Fish Passage Plan (FPP) Change Request Form

Change Form # & Title: 16BON002 – PH2 Mid-Range Operation
Date Submitted: December 17, 2015; Revised January 29, 2016
Project: BON
Requester Name, Agency: FPOM Bon Ops Task Group
Final Action: APPROVED – January 29, 2016

FPP Section: BON 5.2.1 - Turbine Unit Operating Range.

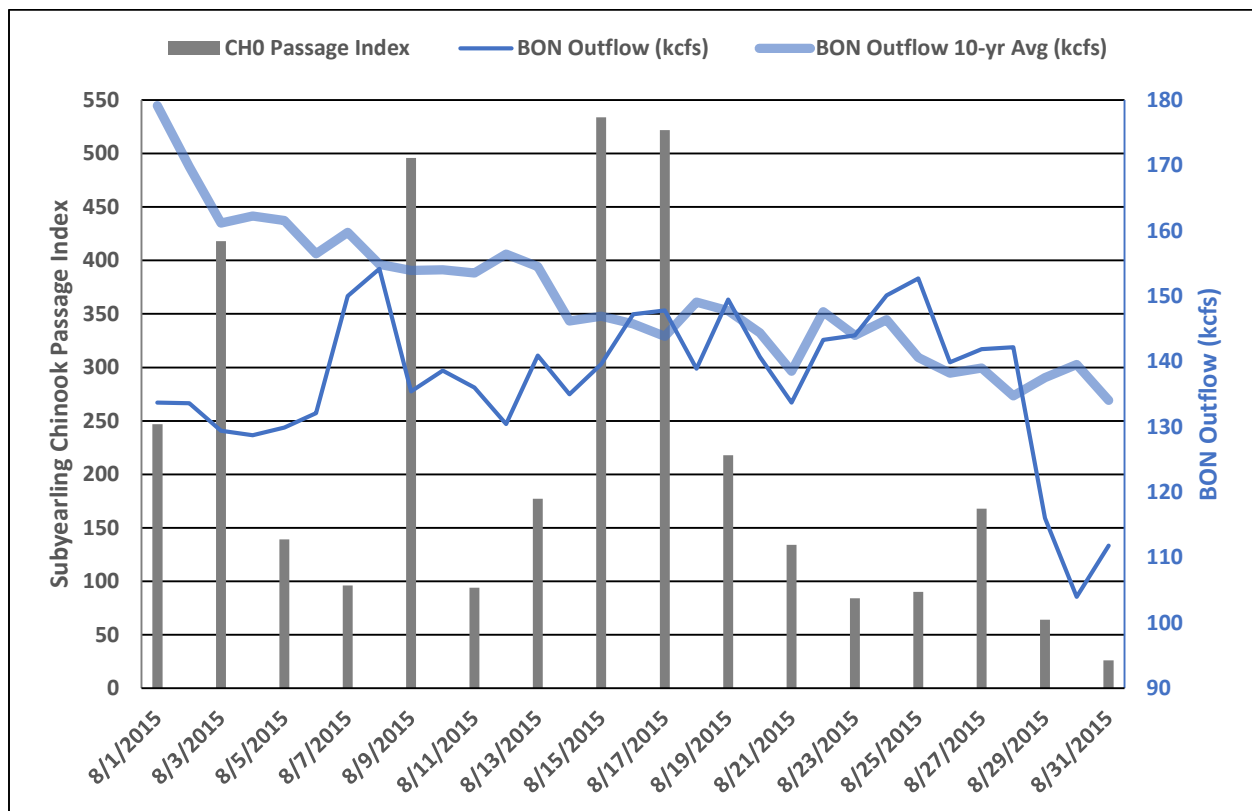
Justification for Change: Change form [15BON006](#) was approved by FPOM for the 2015 FPP in order to reduce deadband issues that occur during low flows when PH2 turbines are restricted to the narrow mid-range of 13-15 kcfs. This change was based on the assumption that PH2 units will rarely be operated above the mid-range in August, consistent with previous years (see FPC Memo [43-15](#), March 13, 2015). Hourly average data for 2015 are summarized in the tables below and confirm that PH2 units were rarely operated above the mid-range in 2015.

- Bettin cautioned that the operators would interpret that wording to be more restrictive and we’d be back to dealing with deadband issues that come up during lower flows with such a narrow operating range. The reality is that PH2 units will only very rarely operate above the mid-range, as shown in last year’s data when there was no restriction in place.

- Lorz thinks 2015 was such an outlier water year that the data aren’t representative, so FPOM should review data from this operation again next year.
- Rerecich confirmed FGE modifications are on-track to be installed next in-water work window 2016/17, so this mid-range operation will likely only be implemented for one more year.

5.2.4.2. **August 1–October 31***: PH2 units may be operated within the full 1% range and PH1 units may be operated up to BOP. During this time period, PH2 units will typically be operated within the 1% mid-range; however, the full 1% range may be used as necessary to avoid deadband issues during lower flows. Operations above the mid-range will be infrequent, consistent with previous years. FPOM will continue to review this operation until FGE modifications are complete.
